2. AMENDMENT/MODIFICATION NO. 0009	3. EFFECTIVE DATE JULY 26, 2001	4. REQUISITION/PURCHASE REQ. NO. N/A	5. PROJECT NO. (If applicable) SPEC. NO. 1154
---------------------------------------	------------------------------------	---	--

14. DESCRIPTION OF AMENDMENT/MODIFICATION (Organized by UCF section headings, including solicitation/contract subject matter where feasible.)
C-130 CORROSION CONTROL FACILITY
HILL AFB, UTAH
NOTE: The Receipt of Proposals Date has been changed to: AUGUST 10, 2001
 DELETE: Attachment No. 23 in its entirety.
 2 Encl.

C-130 CORROSION CONTROL FACILITY

Hill AFB, Utah

Sheet reference number:
C2.7

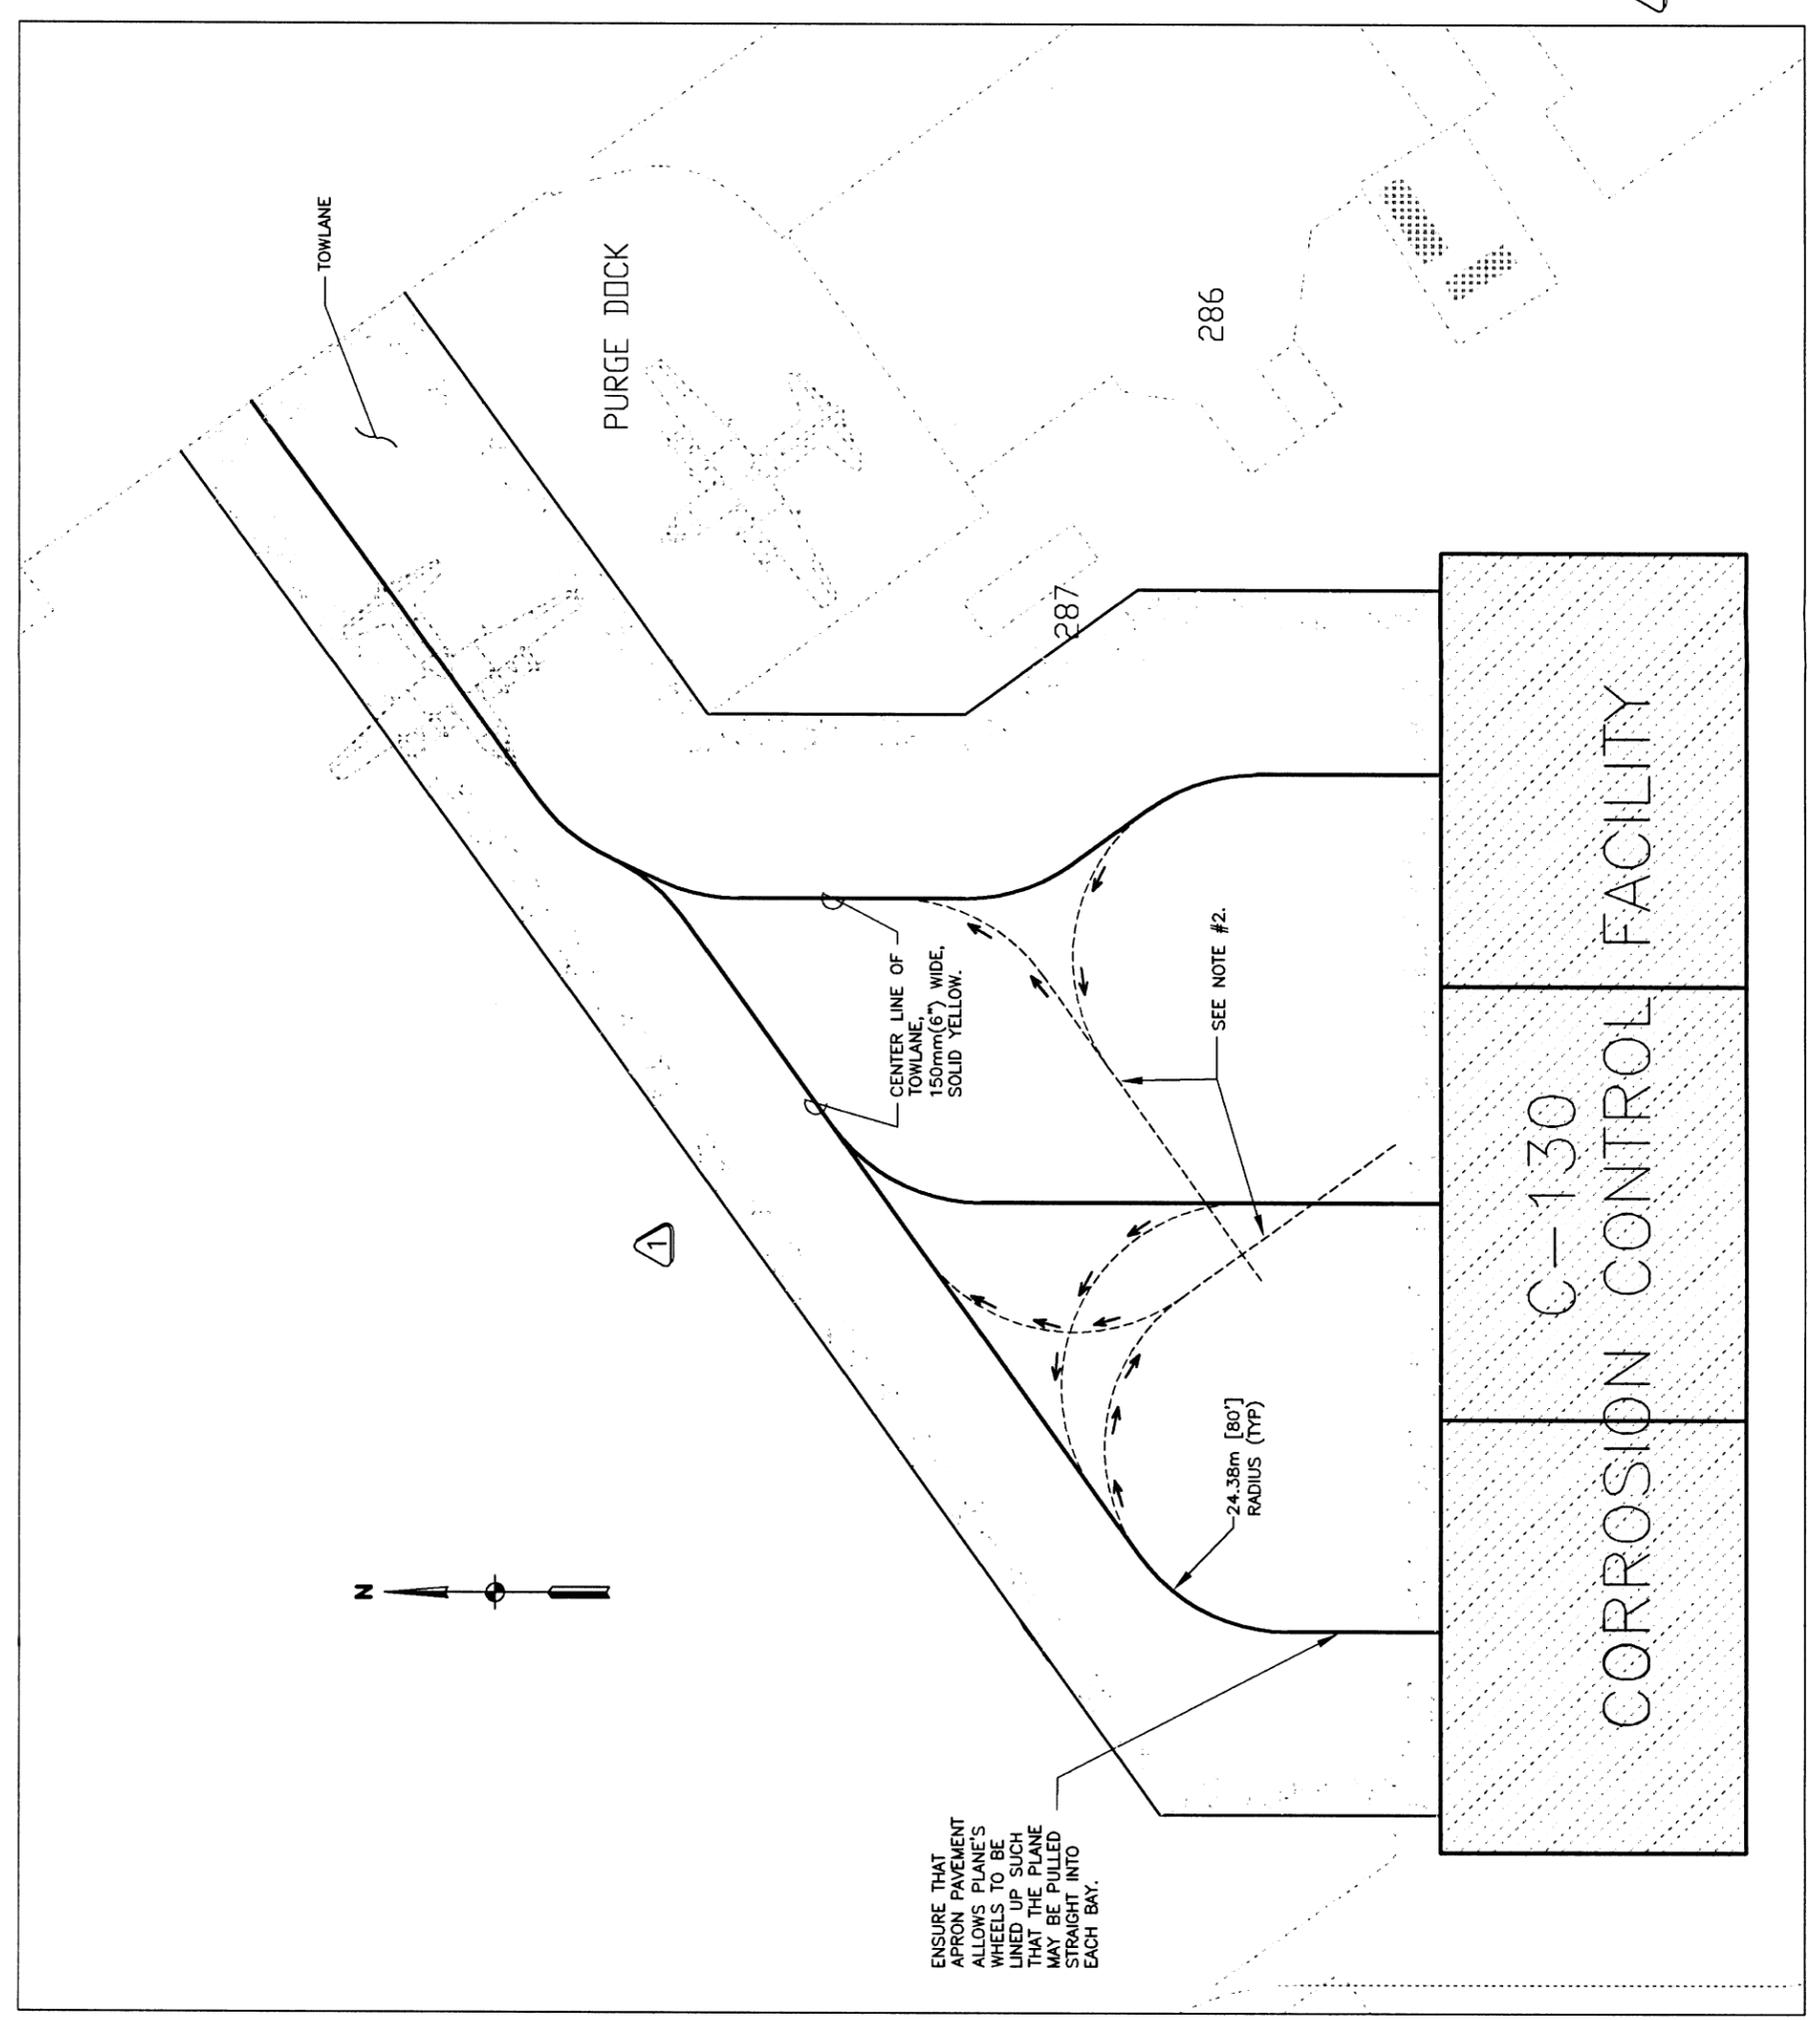
Symbol	Description	Date	Approved
▲	DRAWING MODIFICATIONS & NOTE ADDED

~~placement of pavement for four other aircraft. The paragraph titled "KC 135, C-130 Stretch, F-16 and A-10" shall be used for the preparation of this option.~~ **Pavement striping is required as indicated in Attachment 8, sheet C2.7.**

Provision shall be made for towing the aircraft into **and out of** the hangers. **Turning radius requirements for the C-130 are indicated in Attachment 8, sheet C2.7.** The tugs doing the towing shall be able to pull through the hangers and exit the opposite side of the hangers. Asphalt (**flexible**) pavement is permitted for areas where only tugs are permitted **and for shoulder areas not subjected to C-130 pavement loading.** ~~These areas shall be designed for H-20 loading and shall be a minimum of 12 feet in width. Pavement shall extend from the point that tugs exit the hangers to the point of connection providing access to the apron area and shall be a minimum of 12 feet in width. north edge of 6th Street. AC pavement areas shown on Sheet C2.6 shall be designed for H-20 loading.~~ **Flexible pavement section shall be as indicated in Attachment 24, titled Geotech Report for Airfield Pavement. The paragraph titled "C-130 STRETCH" shall be used for the flexible pavement.** In every area where existing pavement is disturbed, either from building construction, pavement installation or due to construction operations, this pavement shall be replaced with an asphalt pavement section designed for H-20 loading. Sawcut existing pavement as required to provide a good joint and smooth transition from existing pavement elevation to the project building or pavement being transitioned to. Transitions shall be graded as required to provide slopes not exceeding 5 percent.
